Redevelopment Agency Work Session Notice

## **REVIEW OF PROPOSED FIRST AMENDMENT TO THE MIXED USE ZONE MASTER DEVELOPMENT AGREEMENT (MUMDA) FOR PHASE 1 OF THE OGDEN BEND MASTER PLANNED COMMUNITY**

**DATE:** January 15, 2016  
**TO:** Ogden City Redevelopment Agency  
**THRU:** Mark Johnson, CAO  
**FROM:** Tom Christopoulos, CED Director  
**RE:** Amendment to Ogden River Bend Phase 1 exhibit for townhome building elevations at 267-277 Park Boulevard.  
**STAFF CONTACT:** Greg Montgomery, Planning Manager

**Agenda Name: Amendment to Ogden River Bend Phase 1-Townhome building elevations at 267-277 Park Boulevard**

1. Exterior building elevation and material call out.
  2. Colored rendering of front elevation.
  3. Floor plan
  4. Perspective of front
  5. Suggested area of brick placement
-

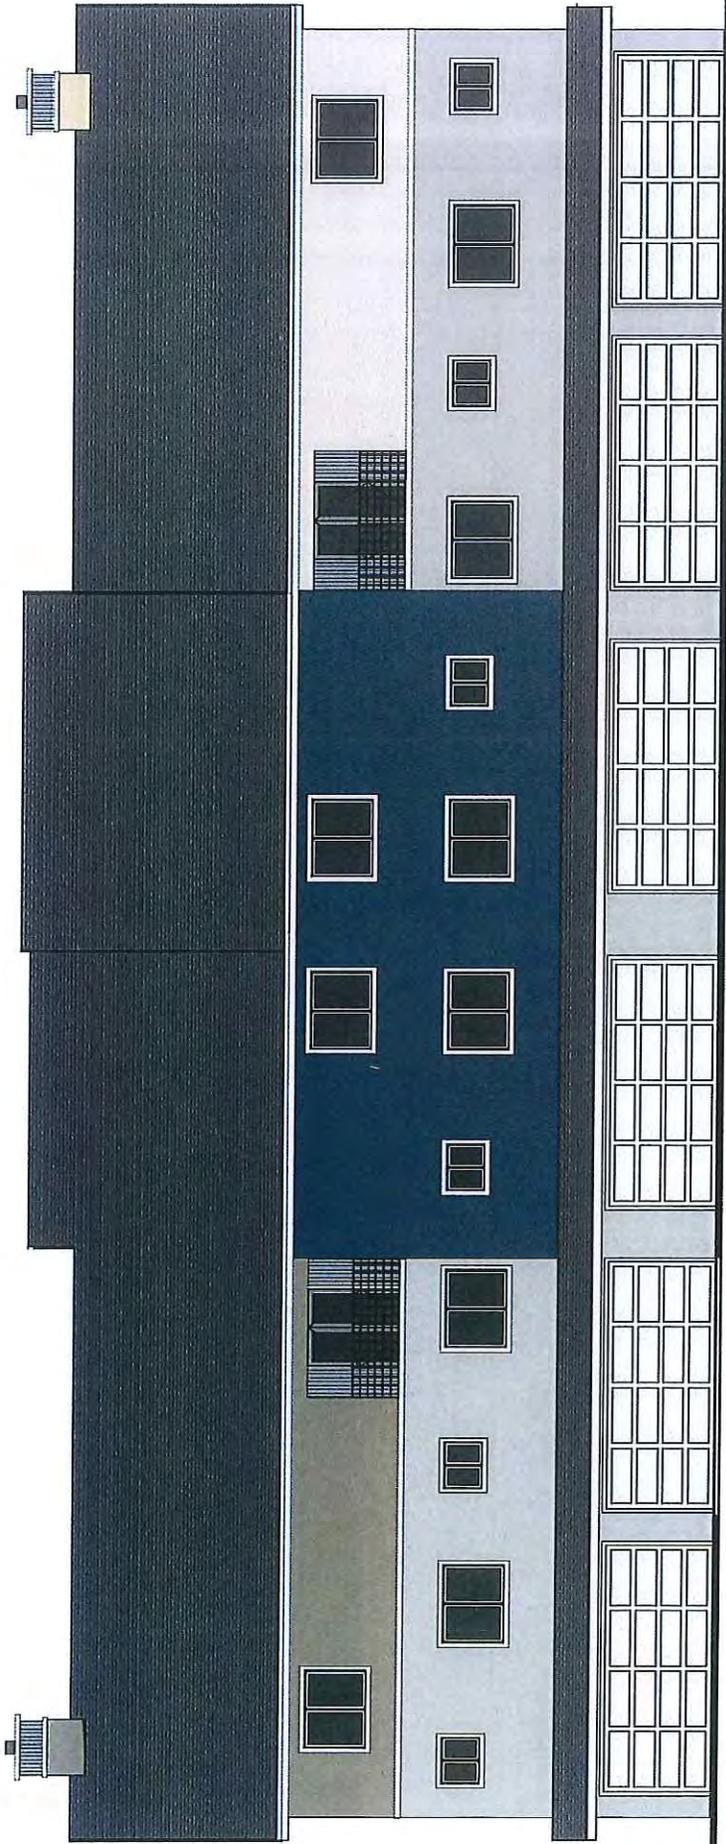
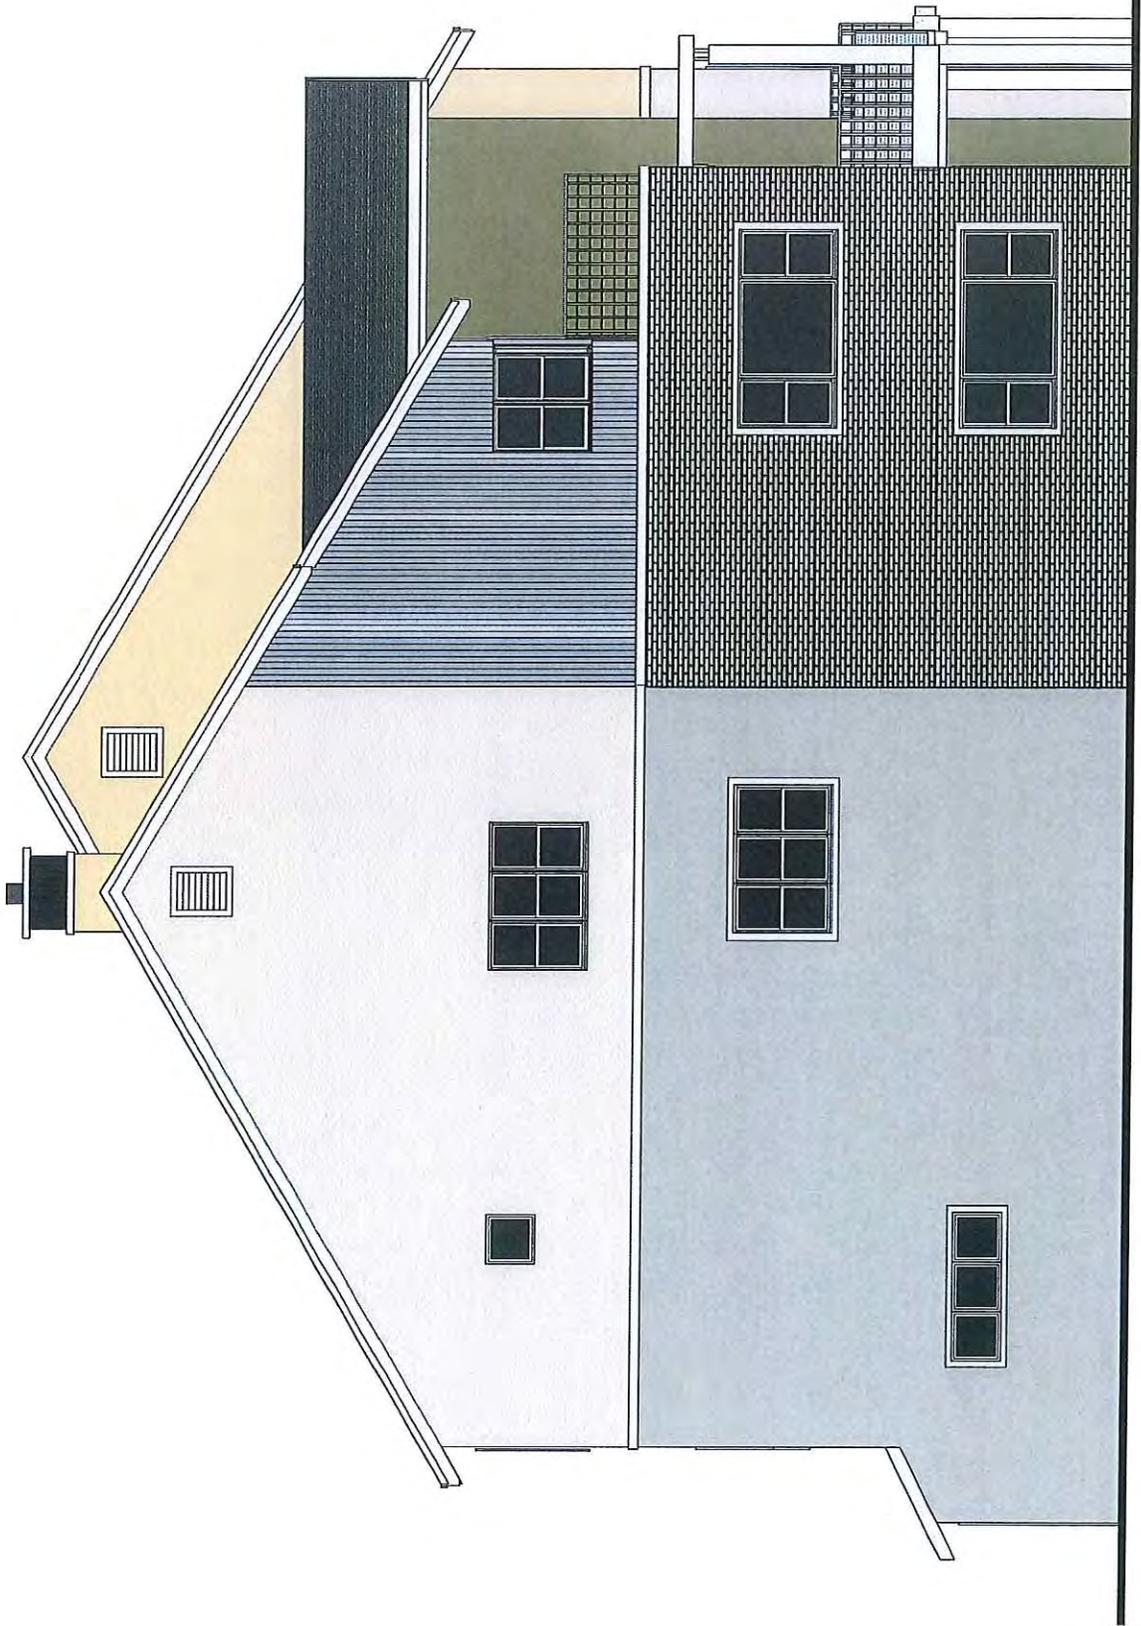
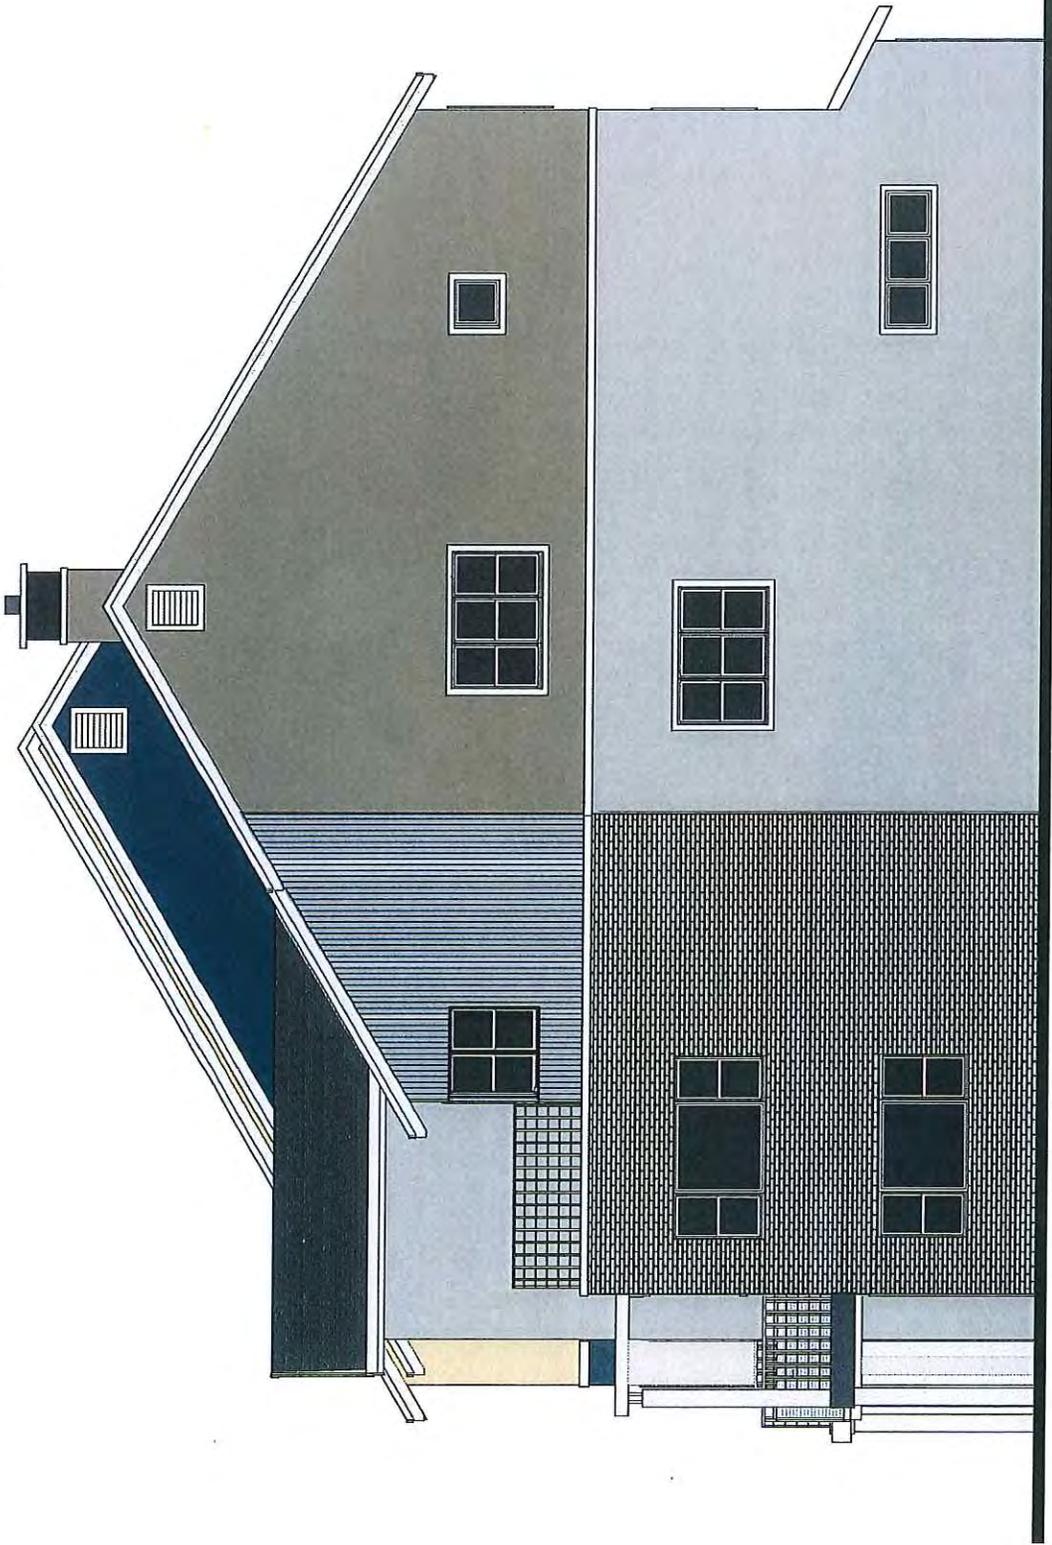
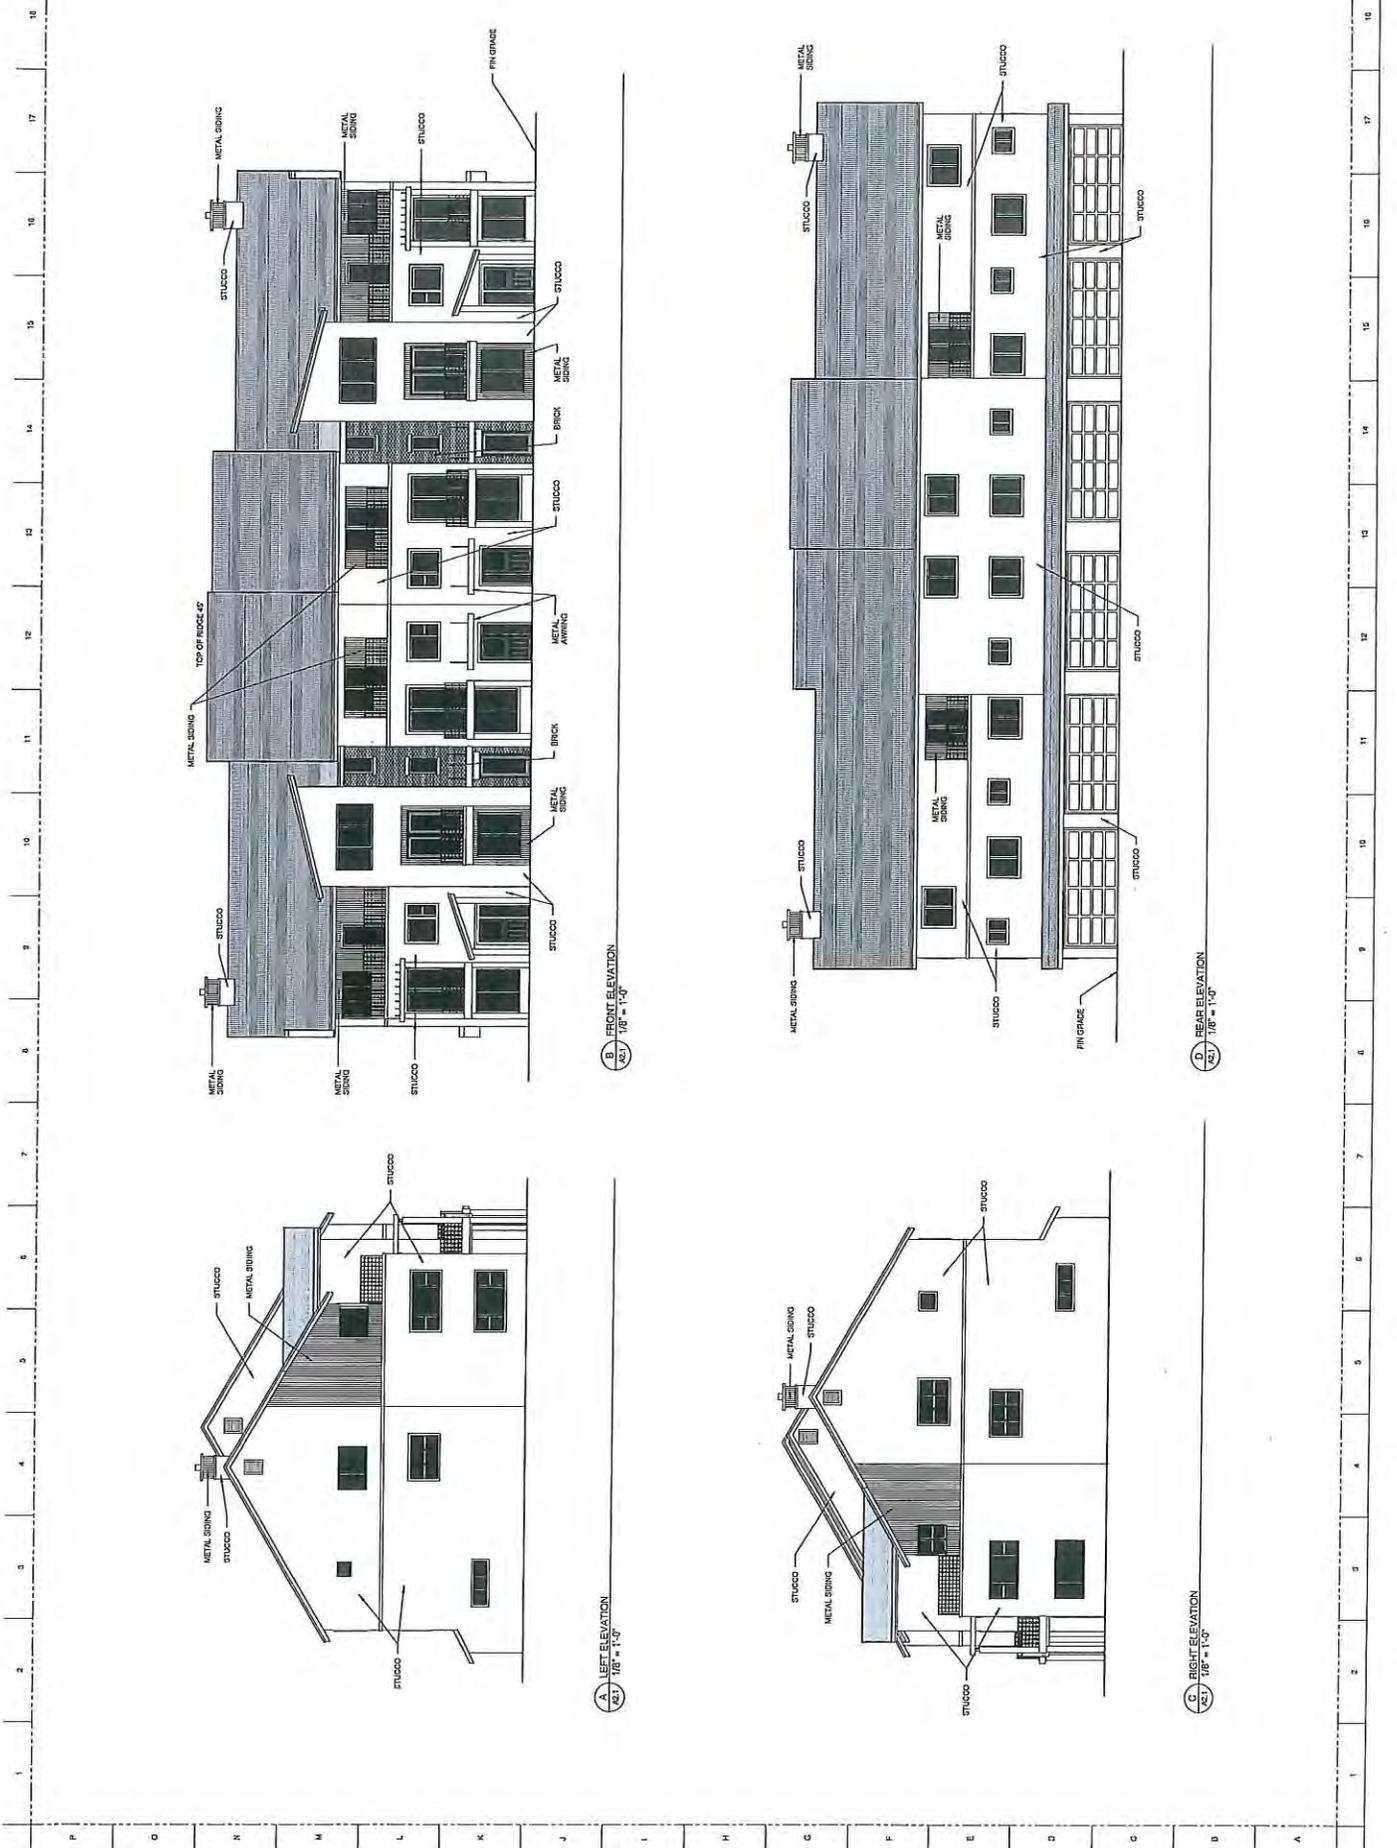
New materials such as metal siding on the third level of the end units and around the windows of the second to the end units is proposed. While not a traditional residential material it is something that can be found in transitional modern design and its use is according to a pattern for the building. The following pictures show the use of this type of metal in other residential buildings.

Staff's only concern is that the material not be highly reflective but have a matted finish.

The next area of concern deals with the brick treatment on the building. There is a small area of brick above the second door from each end of the building. There is a large amount of brick used throughout the block development on the ground level. Staff feels that there needs to be a continuity of that material used in this building at the ends of the building. There is a perfect module at the east and west end of the building that is two stories and can wrap around the corner to an area where the wall plan changes. This would help bring a common use of material in different ways along Park Boulevard.

The townhomes have 10 foot setback from the sidewalk at the end units. The patio area is shown as a concrete area but there is nothing to create a line of change from the public sidewalk to the patio. There needs to be a definition of space by adding a fence around the patio and then having landscaping in front of the fence to soften the transition between the two spaces. Using the same type of metal railing found on the upper balconies on the ground level would be an easy way to define this space and using taller grasses in the small space between the fence and sidewalk would give the texture needed to make a good transition from the public to the private space.

1. Having a non-reflective coating on the metal siding used on the building.
2. Adding brick on the two story module of the end units and wrapping the brick on the sides to the wall extension.
3. Adding a fence along the ground level patios and ornamental grasses to separate the space from the public sidewalk.
